From: no-reply@weebly.com
Sent: Tuesday, April 06, 2021 11:02 AM
To: Caln Township Information
Subject: New Form Entry: Right to Know Request - Caln Township

Please send me all records for 1104 North Bailey Road.

RE: Single Family Dwelling

PERMIT REVIEW: Single-Family Dwelling T.P. #39-1-78.1

SERIES 550 SINGLE HUNG WINDOW

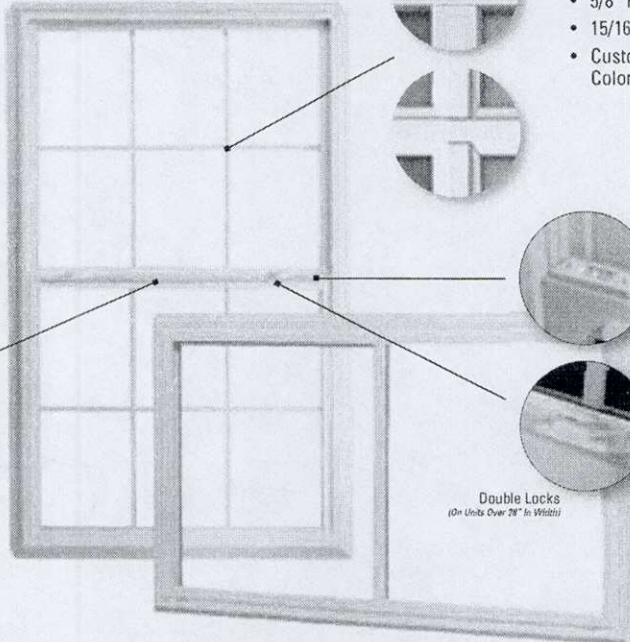
2. Provide Manufacture's specifications showing at least one window in each bedroom will meet the Egress requirements of Section R310.1.1 of the 2000 IRC. Windows of this nature must meet a minimum 5'7"sq.ft. of net clear opening; minimum height shall be 24", minimum width shall be 20"

Call Size: 3050
R.O. : 36" x 60"
Meets 5.7 sq. ft. egress

PROPOSED PARKING

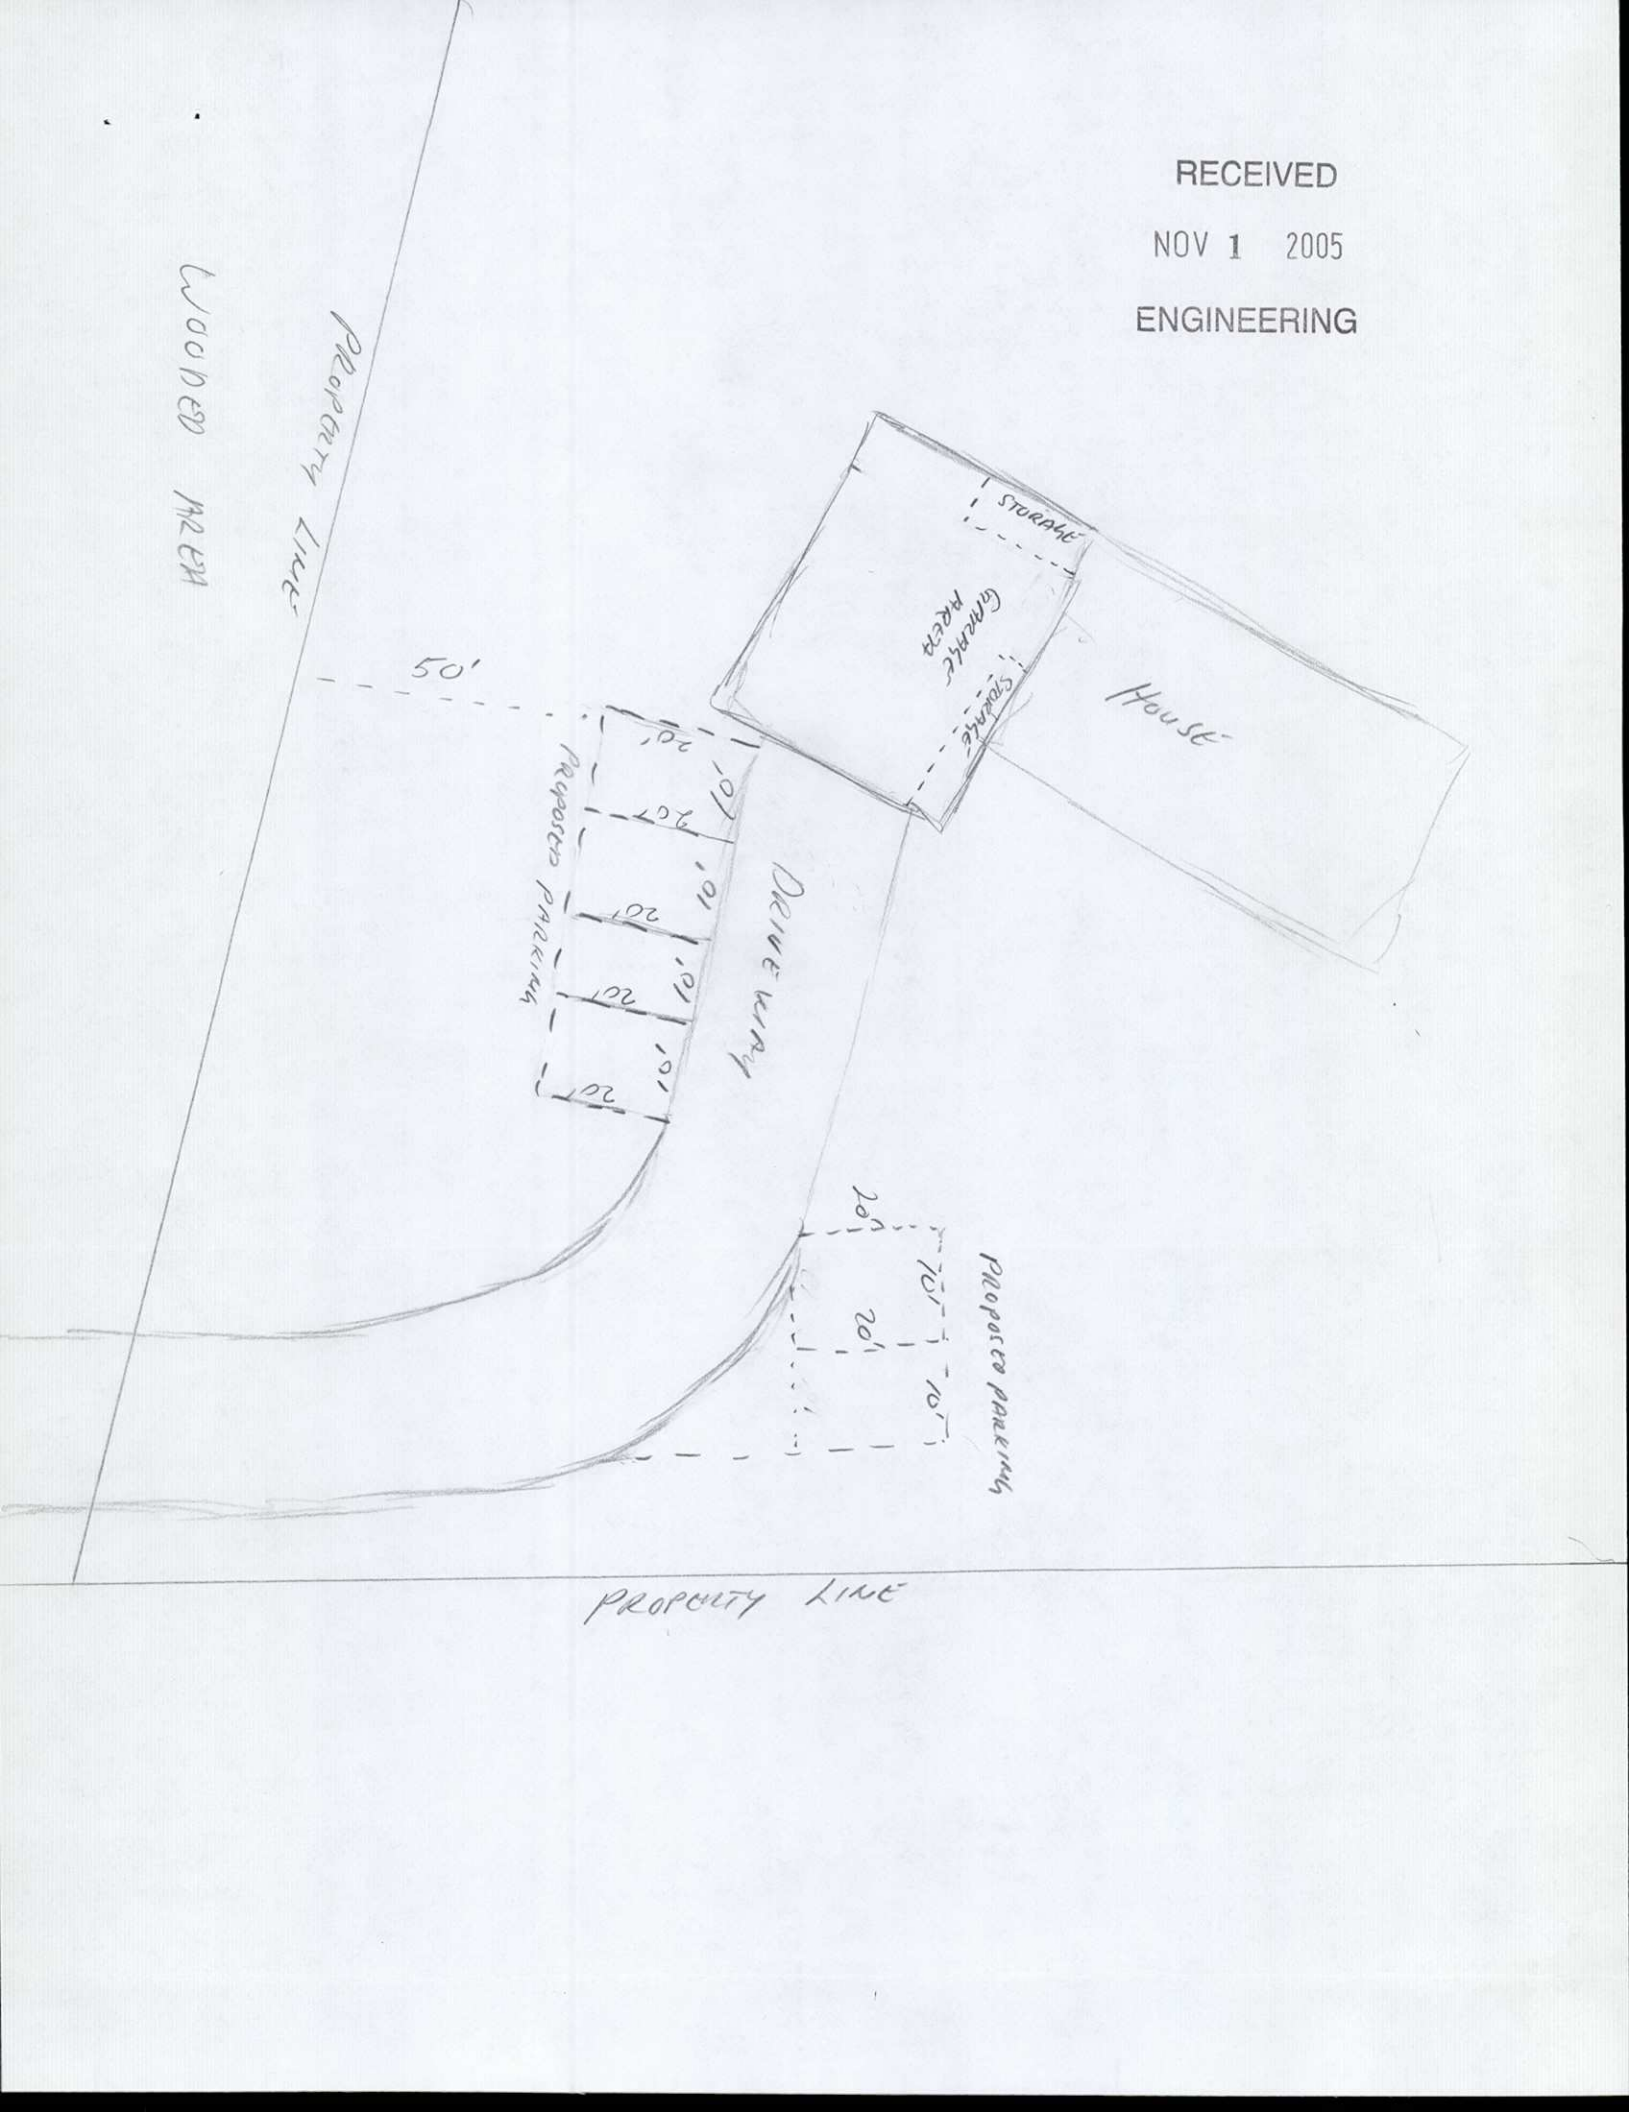
- 1) Please provide a floor plan showing the overall dwelling and its relationship to the proposed work area. Section 155-109 [C] (2) limits this space to no more than 25% of the overall gross floor area or no more than 500 sq.ft. I understand you are suggesting a space of 800 sq.ft.
- 2) The floor plan shall also establish an inventory storage and stockpile area. All storage of materials are required to be indoors
- 3) Please provide a plot plan establishing the location of the all six required parking spaces. Parking spaces are required to be 10' in width and 20' in length.
- 4) Please understand all activities of this nature shall be conducted in a manner so as not to be detectable at or beyond the property line.

I am writing you to provide additional information, which you requested regarding my permit approval. The working area that I would like to use is my two-car garage (please see attached drawing). I have also provided a storage area within the garage. In addition, I have marked where the six parking spots would be located. I also understand that all activities of this nature will be conducted in a manner so as not to be detectable at or beyond the property line.

SEE ATTACHED
PLOT PLAN

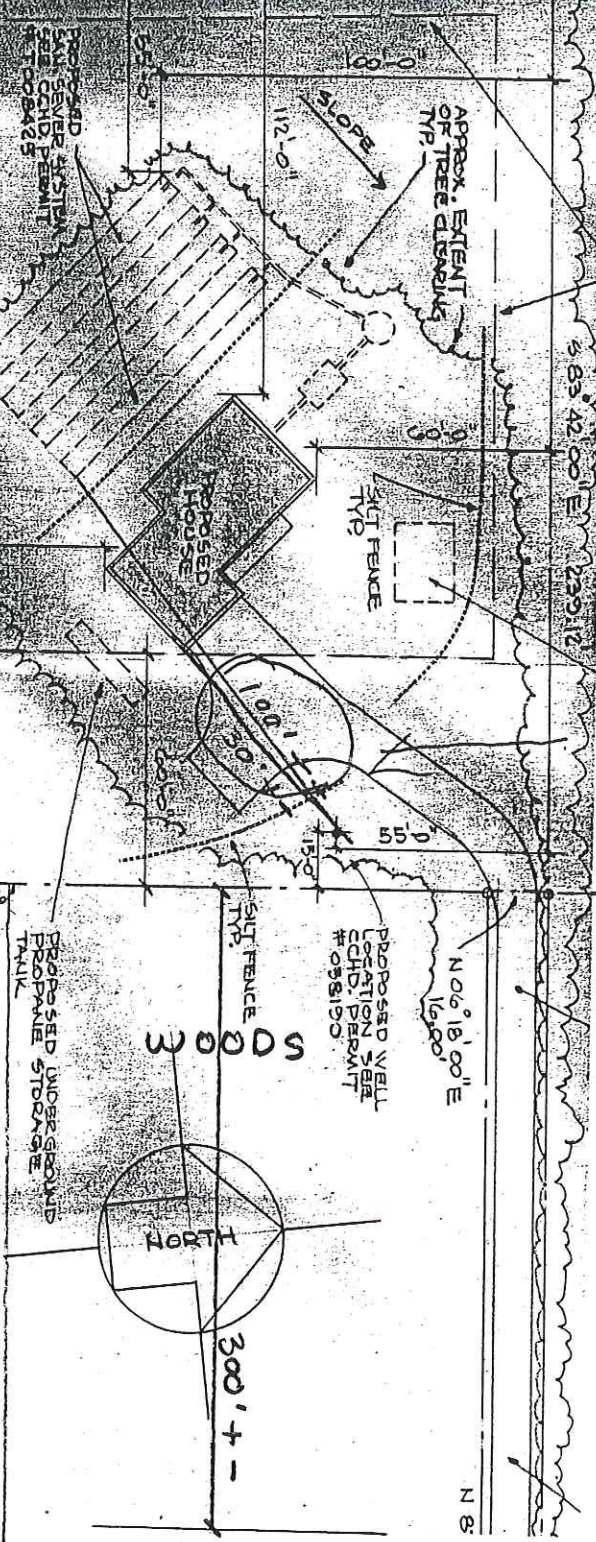
NOT accurate
IN formation
poor planning

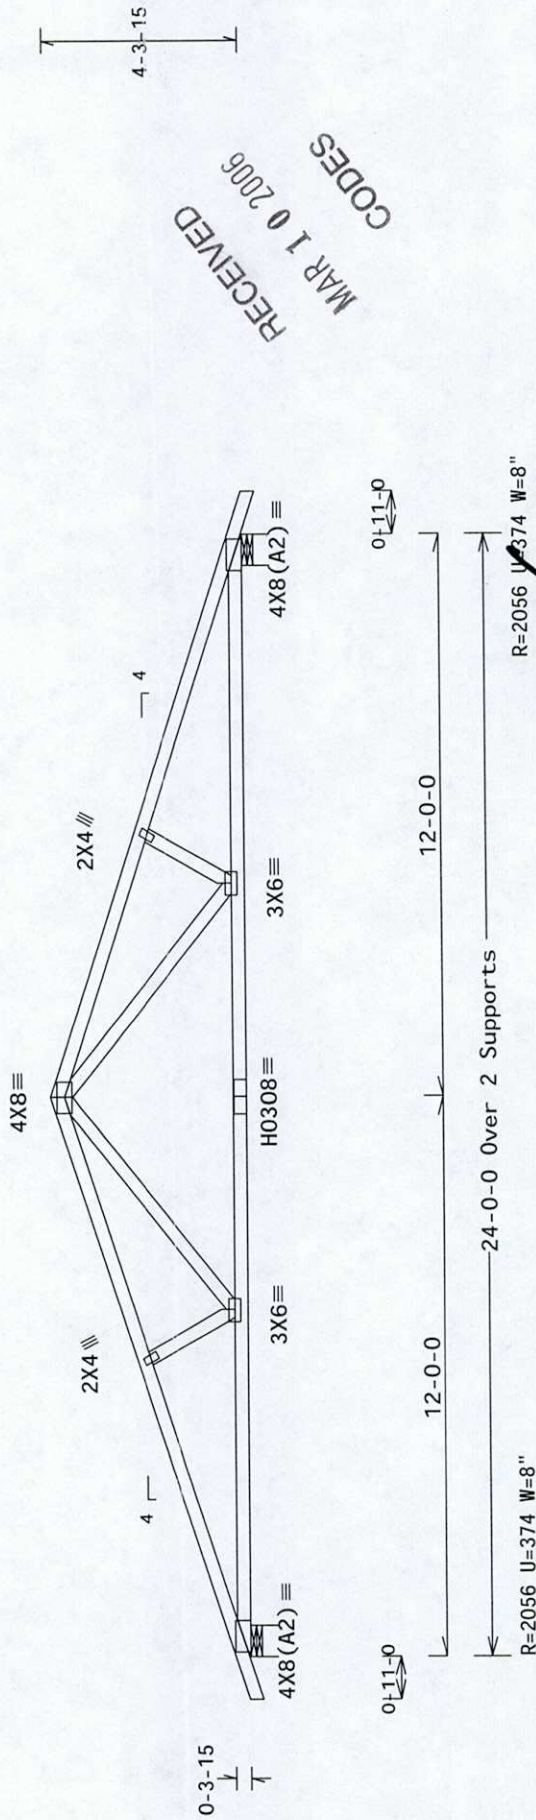
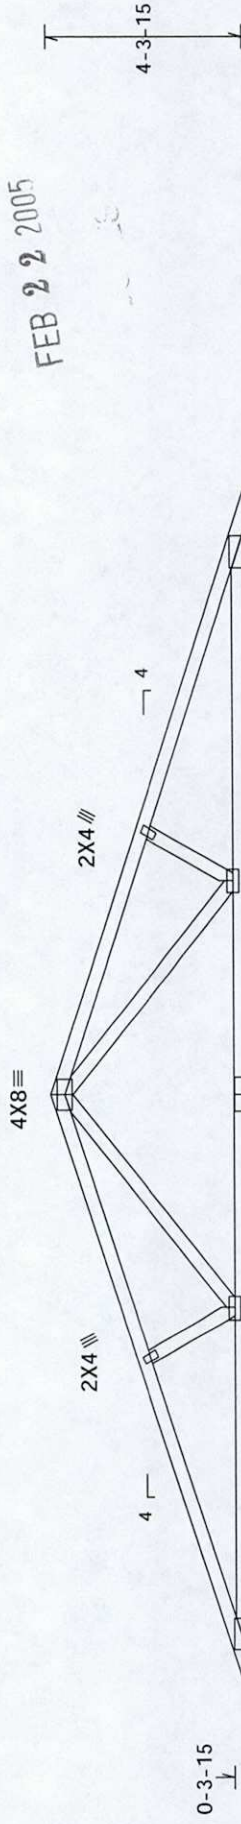
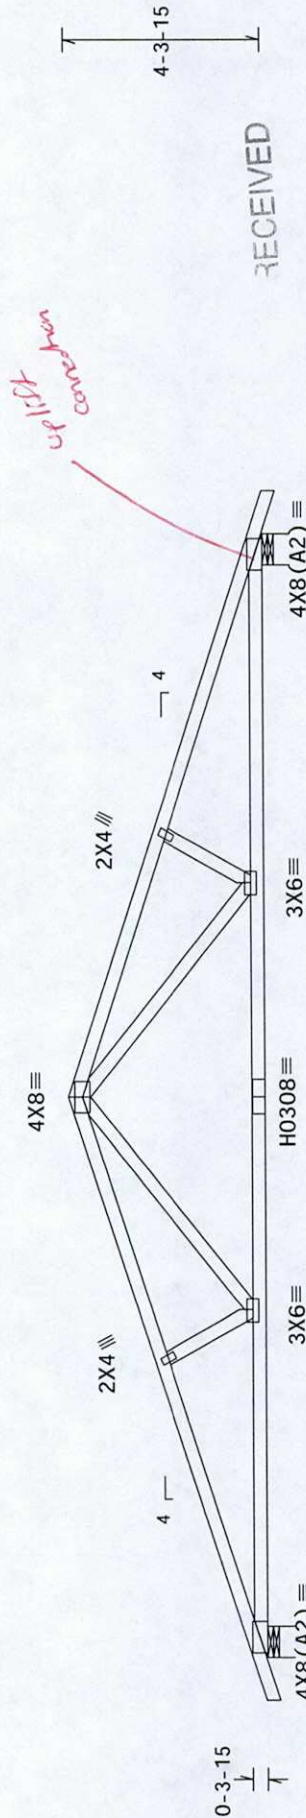
- 3) The "Truss Tie Down" detail is not sealed by a design professional. Figure R802.5.1 establishes the required truss connection to resist uplift for trusses spaced a maximum of 24" on center. Your plans reference truss spacing of 4' on center. Please provide the design professional's seal and signature on this detail along with the required calculations.

- 3) The "Truss Tie Down" detail is not sealed by a design professional. Figure R802.5.1 establishes the required truss connection to resist uplift for trusses spaced a maximum of 24" on center. Your plans reference truss spacing of 4' on center. Please provide the design professional's seal and signature on this detail along with the required calculations.

OK 3/10/06 ✓
Changed to 2x12 Need Bolted connection
See Graber Supply Change 3/10/06
Not for vehicles
